# TVA Heinemann Molded Case Circuit Breakers (MCCBs)

## Power Board Design:

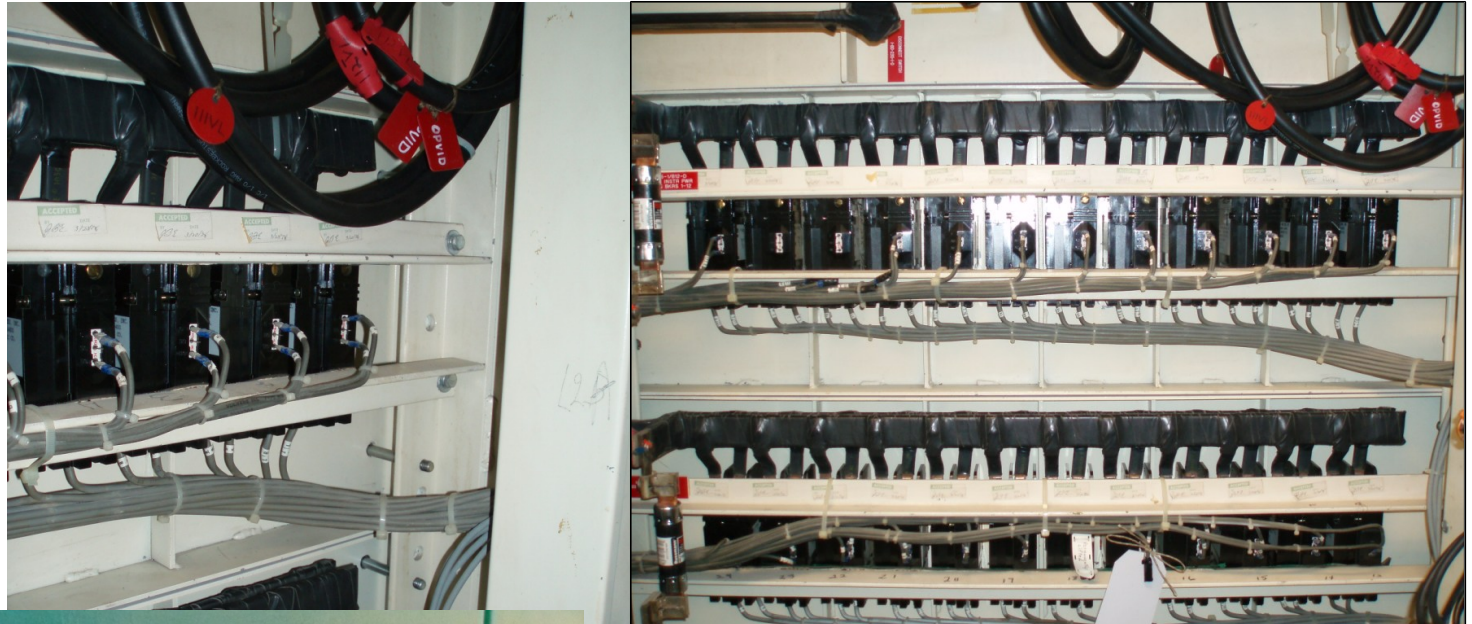
- The MCCBs mounted during testing are not representative of the breaker's clamped arrangement as installed in the plant.
- The test arrangement placed an accelerometer 13 inches below the upper-most row of breakers.
- The circuit breakers, as viewed on past inspections, did not appear to firmly fit into the panel.
- The licensee used spacer materials, not documented on design drawings, as installation aids.
